ADDENDUM NO. 4

DESIGNER: D. GEISSERT	 STATE OF CONNECTICUT DEPARTMENT OF TRANSPORTATION	PROJECT TITLE: CHURCH STREET SOUTH EXTENSION OVER NEW HAVEN INTERLOCKING AND RAIL YARD	TOWN: NEW HAVEN	PROJECT NO.:
DRAFTER: M. OFFENBERG		CADD FILE: AD4R703S001.DGN	DRAWING TITLE: GENERAL PLAN - SHEET 1 OF 2	PROJECT NO.: 92-526
CHECKED BY: A. MORETTI	ENGINEER: PARSONS BRINCKERHOFF QUADE & DOUGLAS, INC.	PLOTTED DATE: 12-8-00	SHEET NO.:	
DATE CHECKED: 4-9-00	APPROVED BY: <i>Anthony A. Moretti</i>		SHEET NO.: 136

PROJECT TITLE:
CHURCH STREET SOUTH EXTENSION
OVER NEW HAVEN INTERLOCKING
AND RAIL YARD

DRAWING TITLE:
WINGWALLS 2A & 2B AND
RETAINING WALL 101 - SHT. 3 OF 3

TOWN: **NEW HAVEN**
 DRAWING TITLE: **BOTTOM LATERAL
BRACING DETAILS**

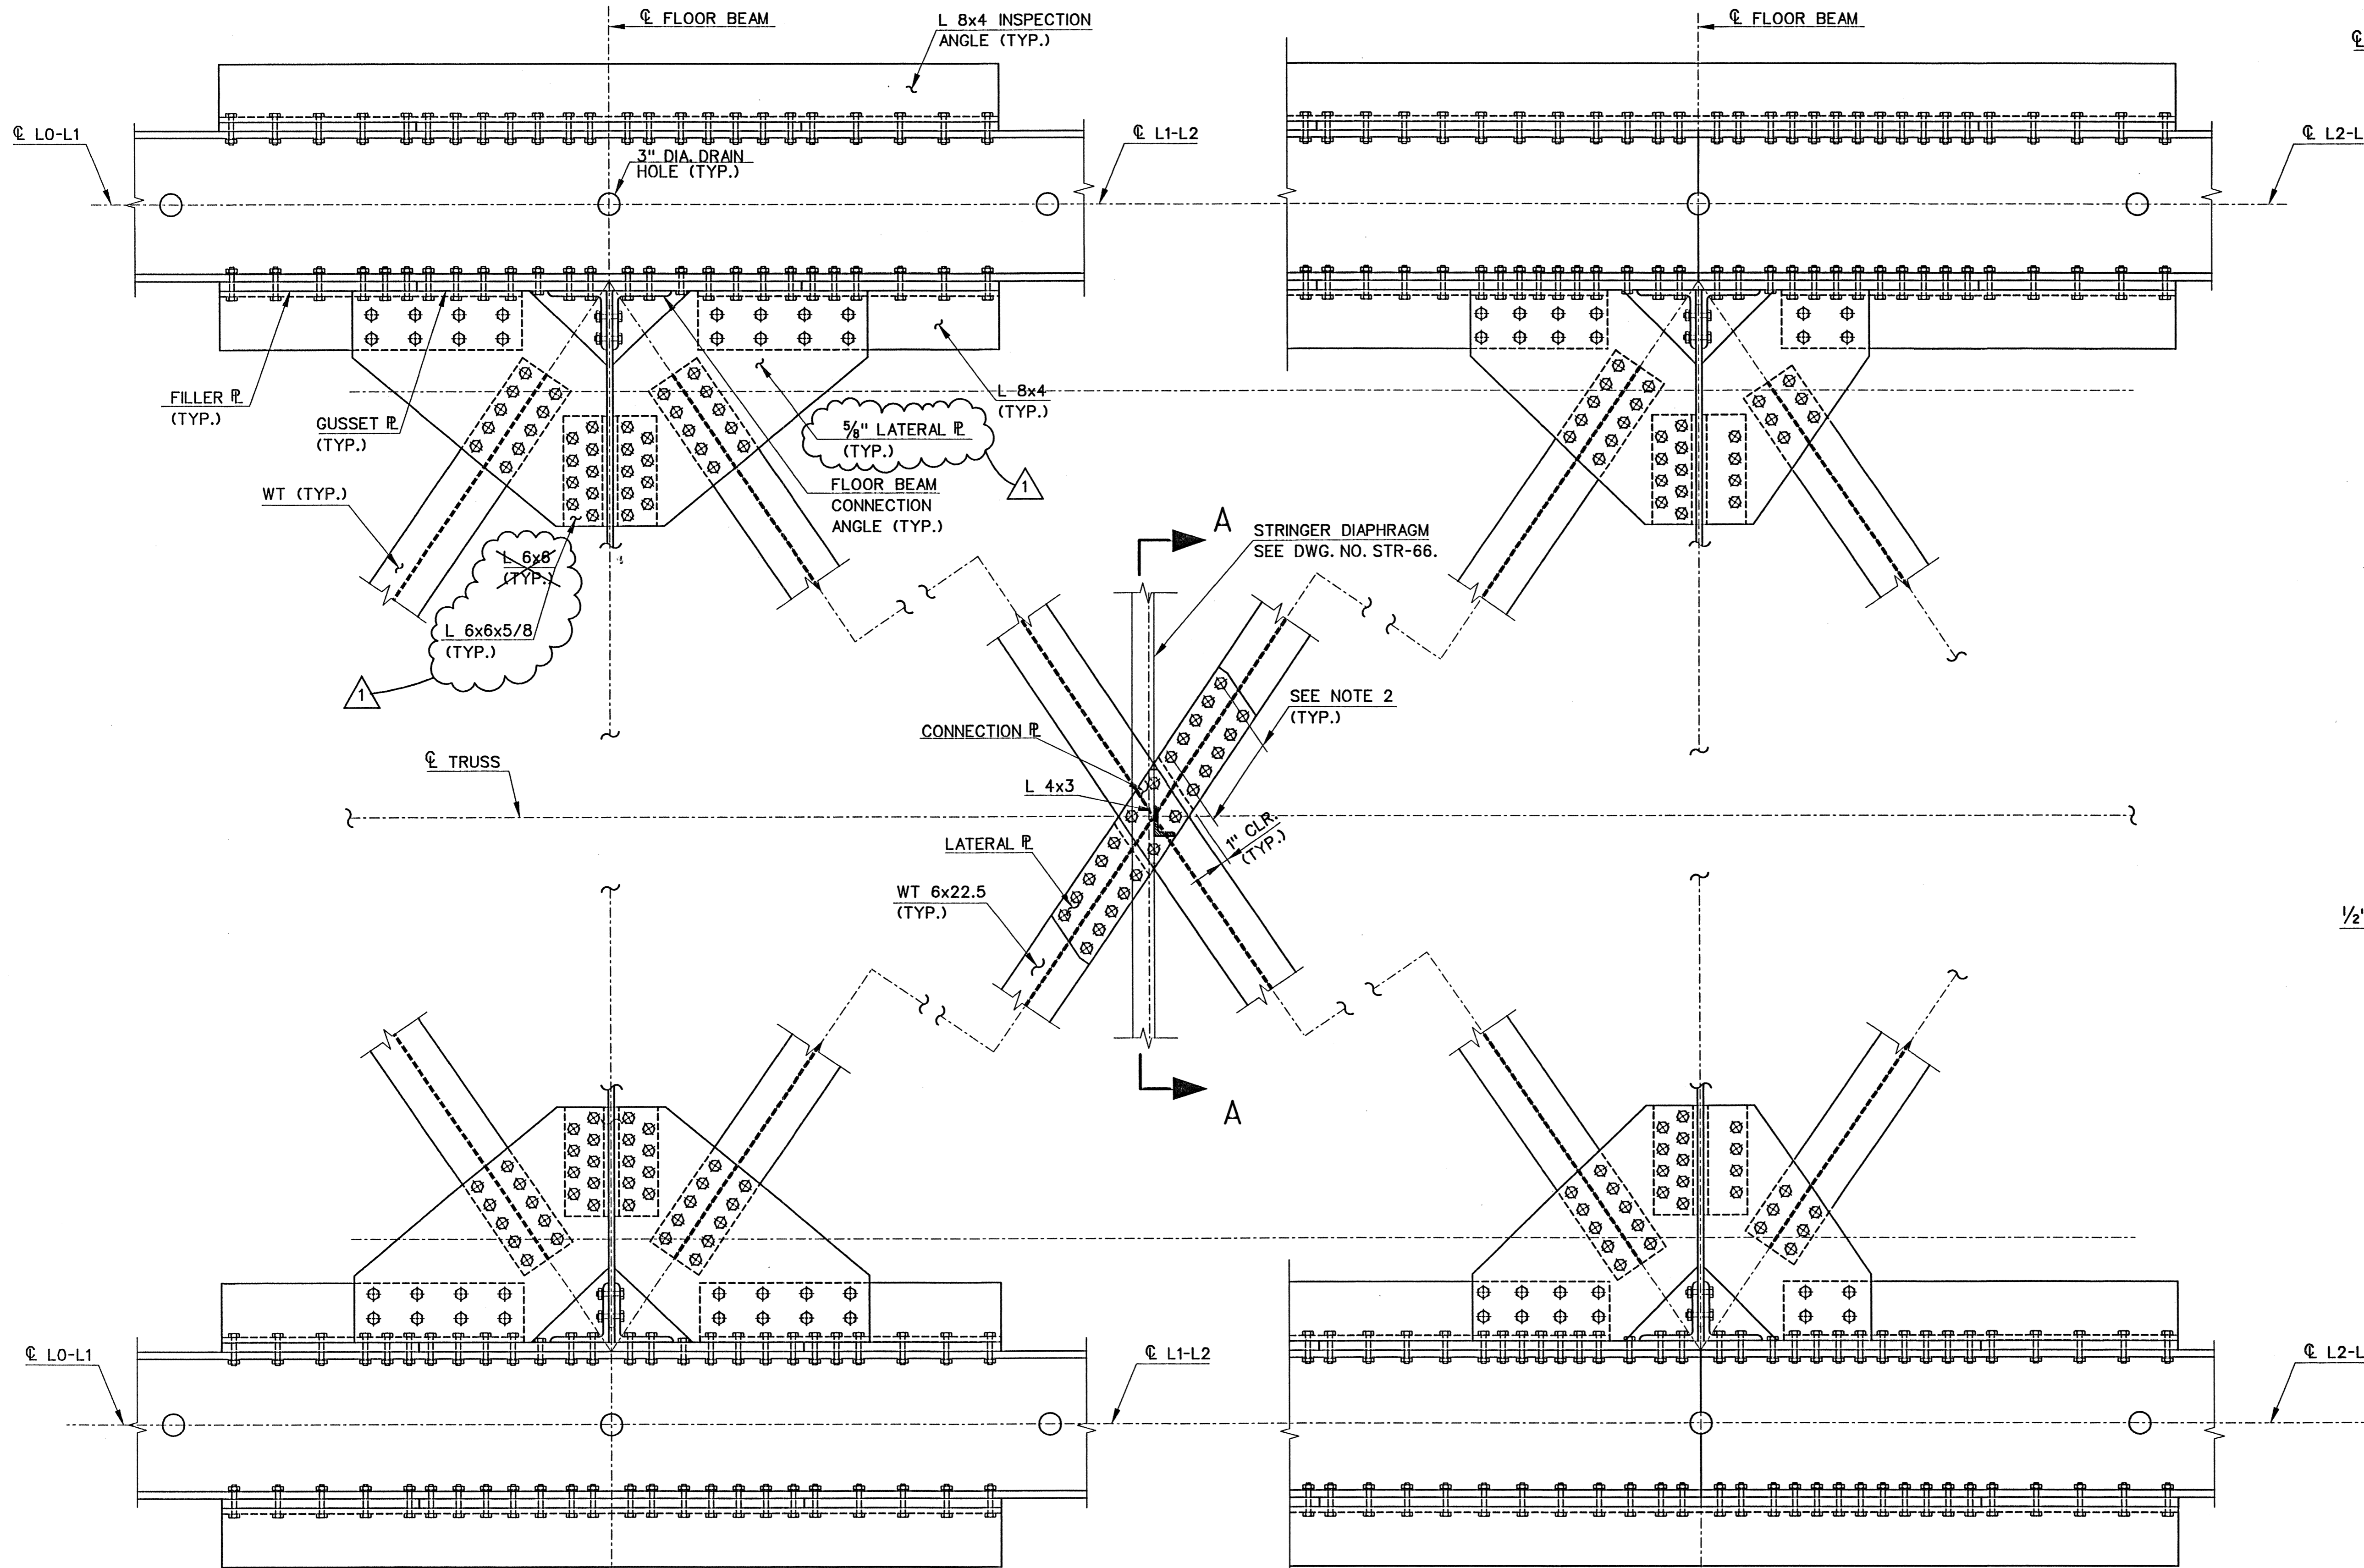
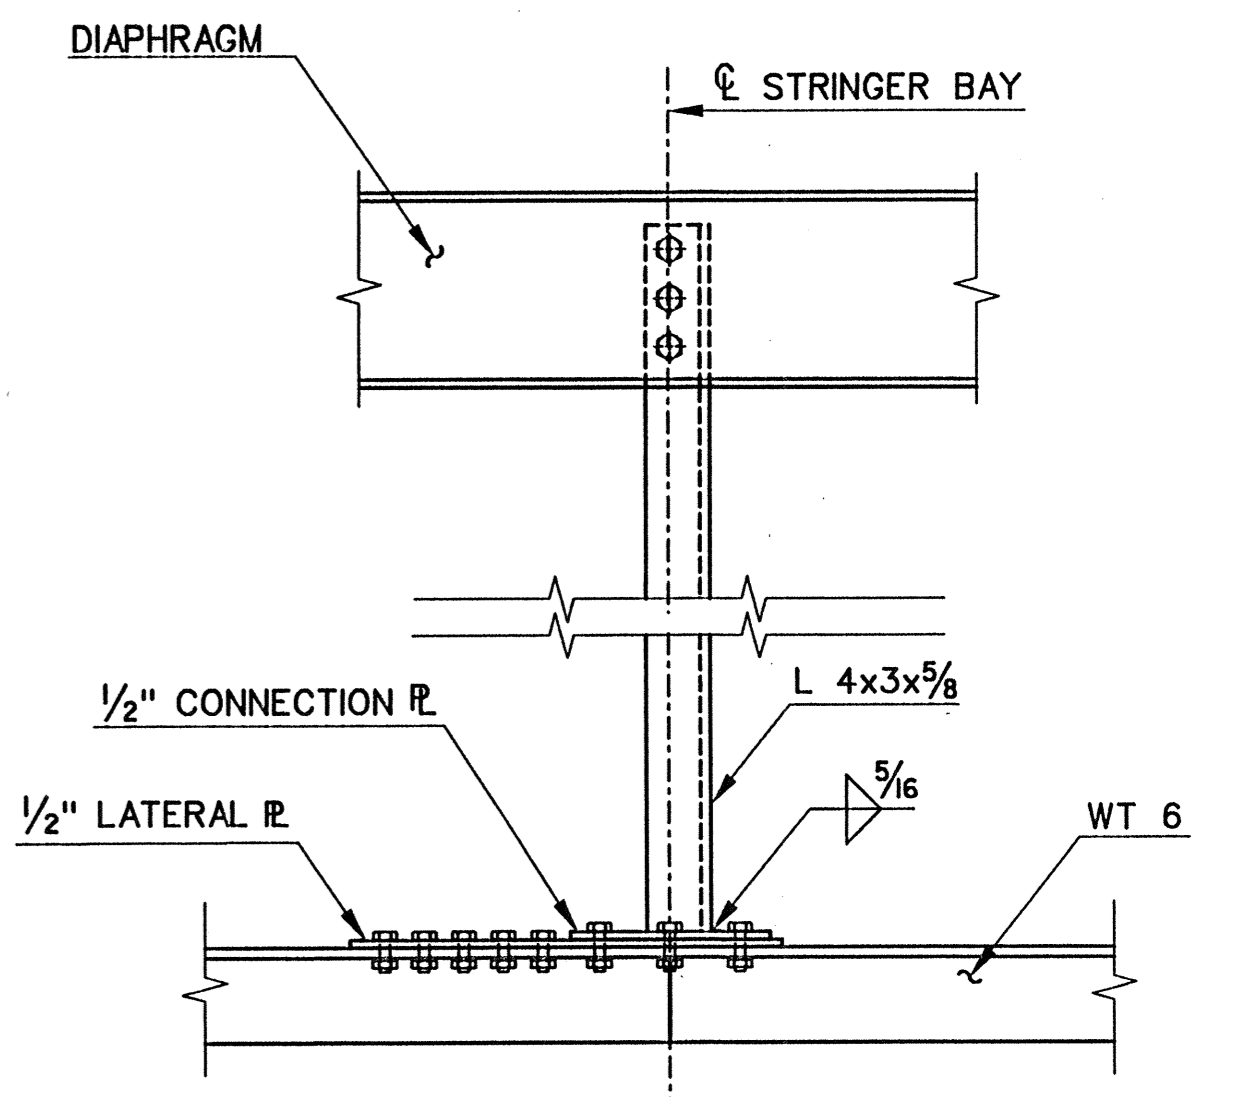
REV.	DATE	DESCRIPTION	SHEET NO.
1	12-8-00	ADDENDUM NO. 4 - LATERAL PLATE AND L 6x6 THICKNESS ADDED	215
		REVISIONS

- NOTES:**
1. DETAILS SHOWN AT PANEL L1-L2, OTHER PANELS SIMILAR.
 - 2.10 BOLTS AT BAYS L0-L1, L1-L2, L6-L7 & L7-L8.
5 BOLTS AT BAYS L2-L3, L3-L4, L4-L5 & L5-L6.

DRAWING TITLE:
WORK AREA LAYOUT PLAN

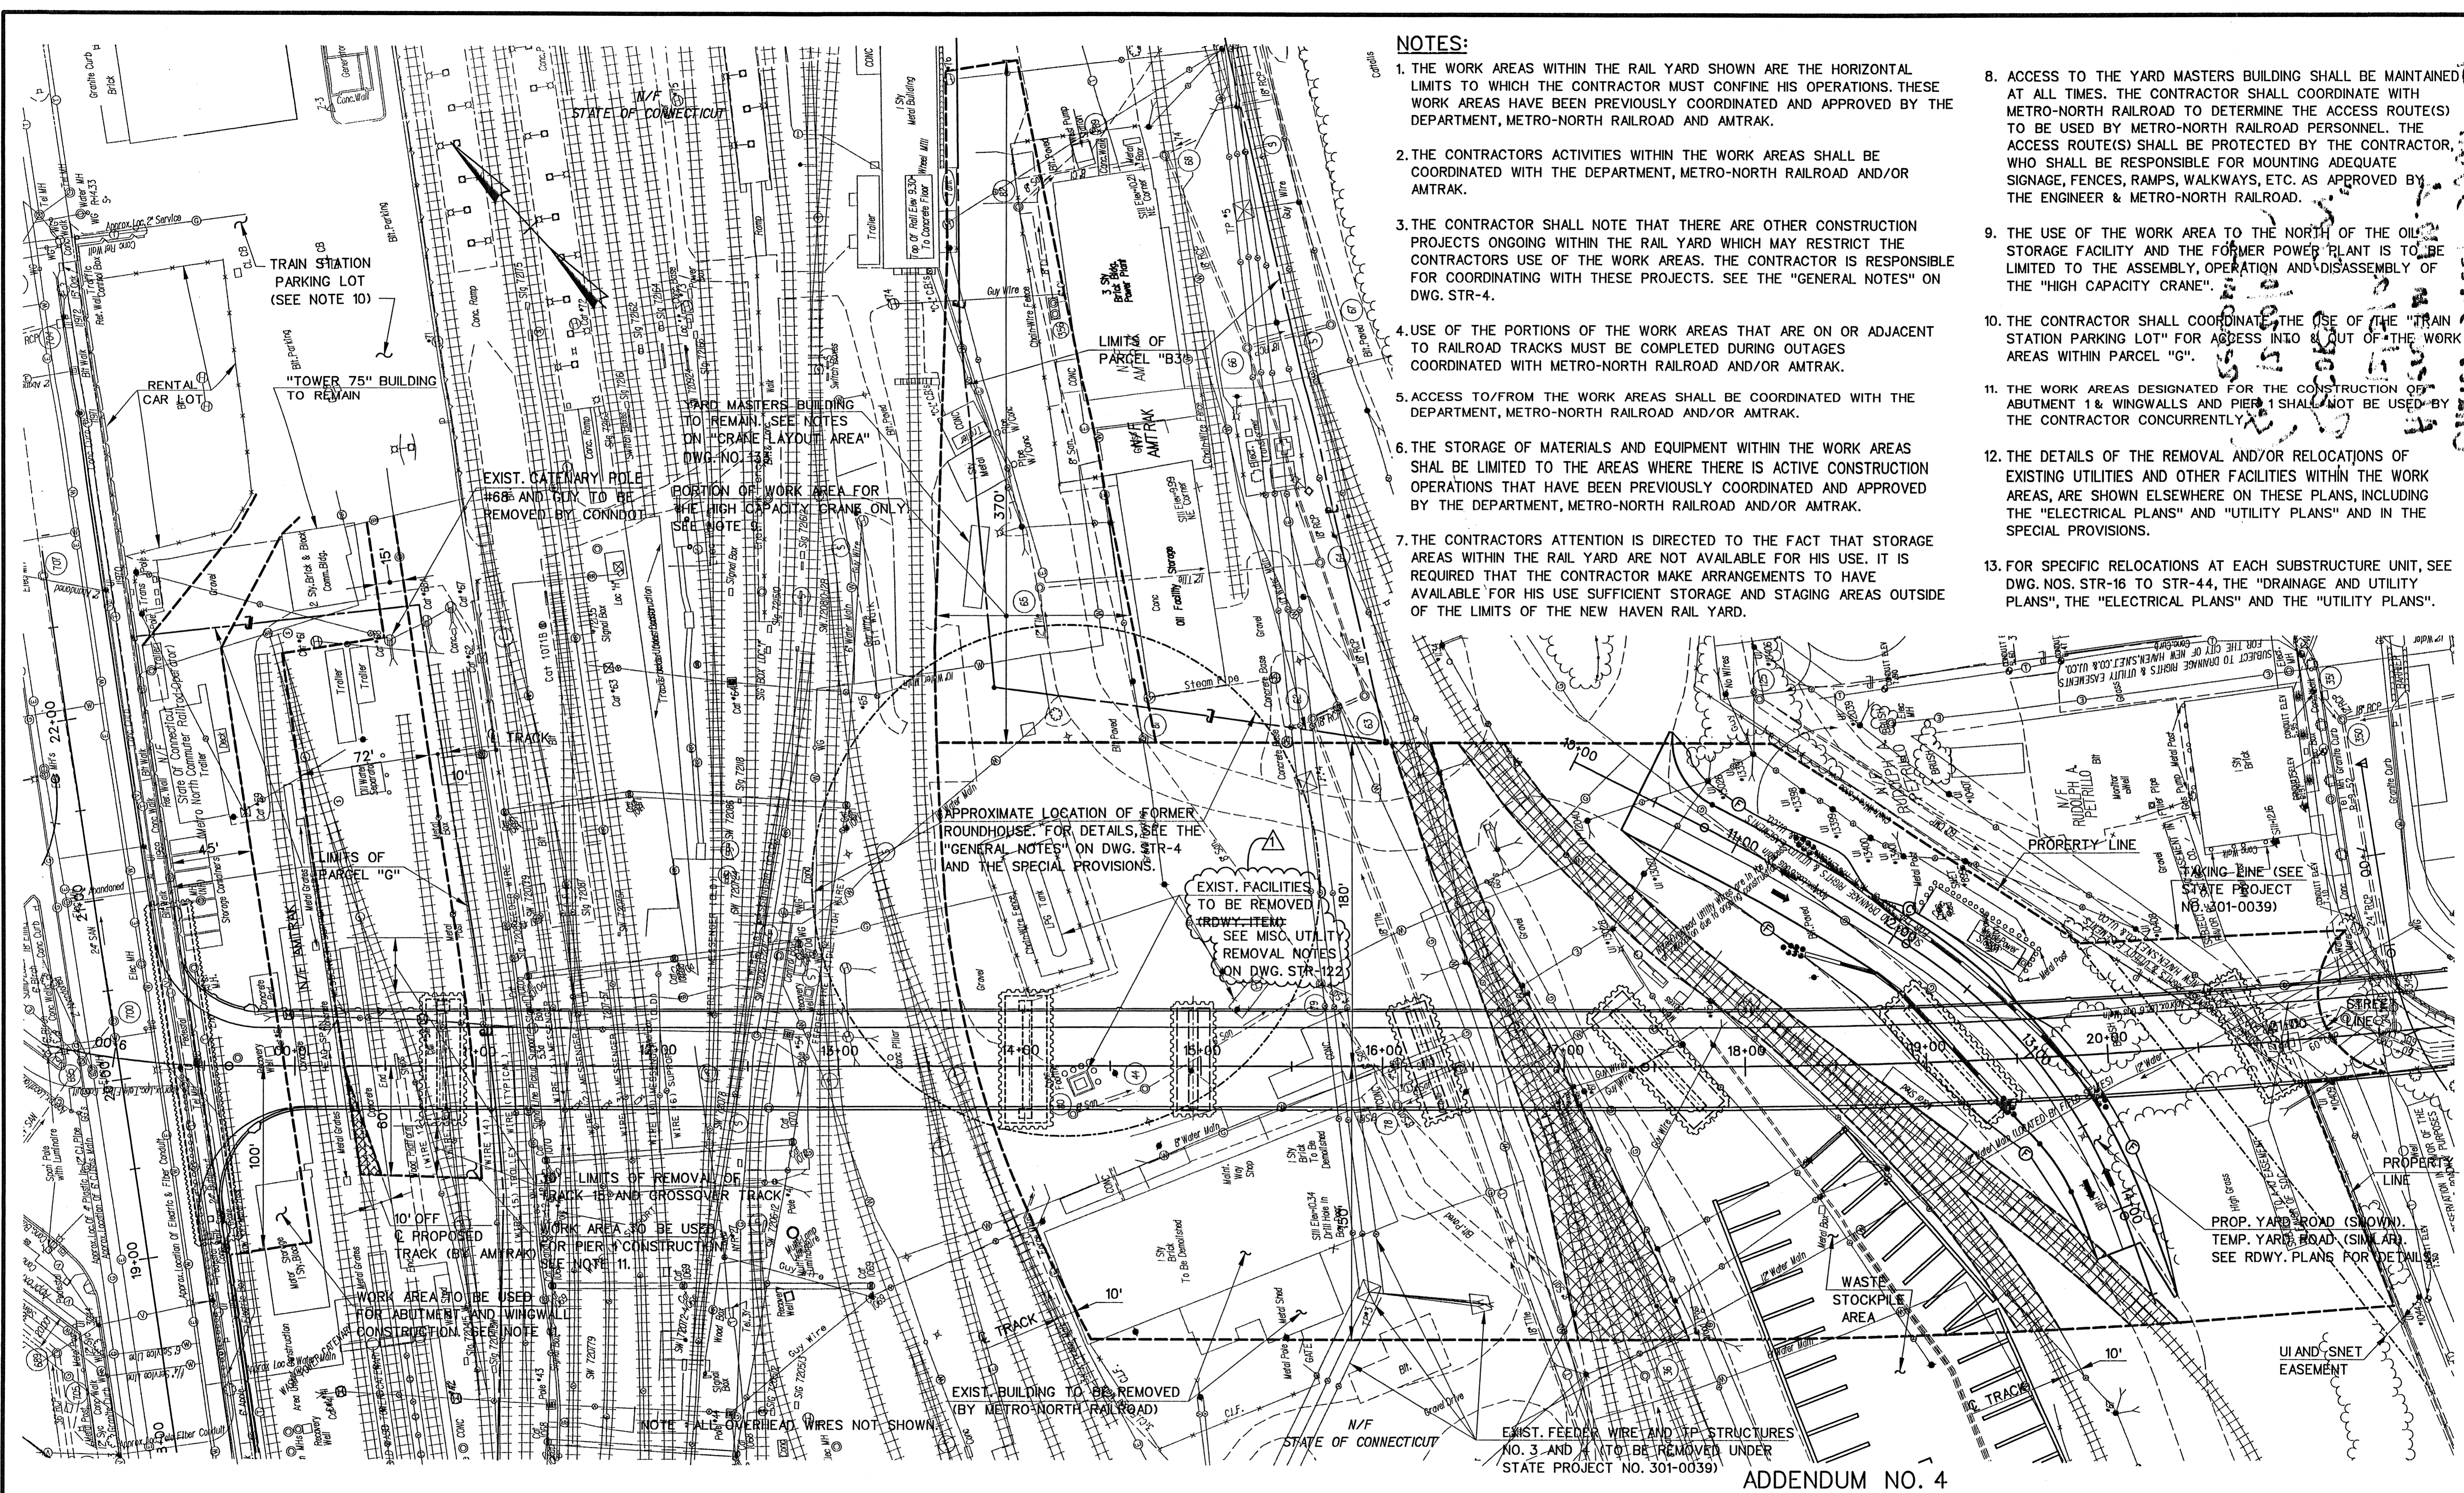
REV.	DATE	DESCRIPTION	REVISIONS
12-8-00		ADDENDUM NO. 4 - EXIST. FACILITIES TO BE REMOVED	257
			SHEET NO.
